SERVICE BULLETIN

Classification: EL20-033	Reference: NTB20-065	Date: September 16, 2020
-----------------------------	-------------------------	-----------------------------

2017-2019 ARMADA; ENGINE DOES NOT CRANK

APPLIED VEHICLES: 2017-2019 Armada (Y62)

Figure 3

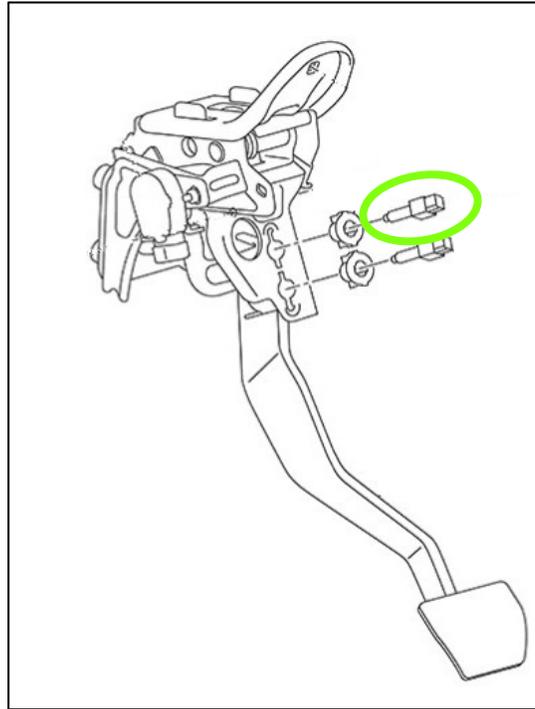
NOTE: The updated stop lamp switch will have a black body with a green connector end.

Replace the stop lamp switch.
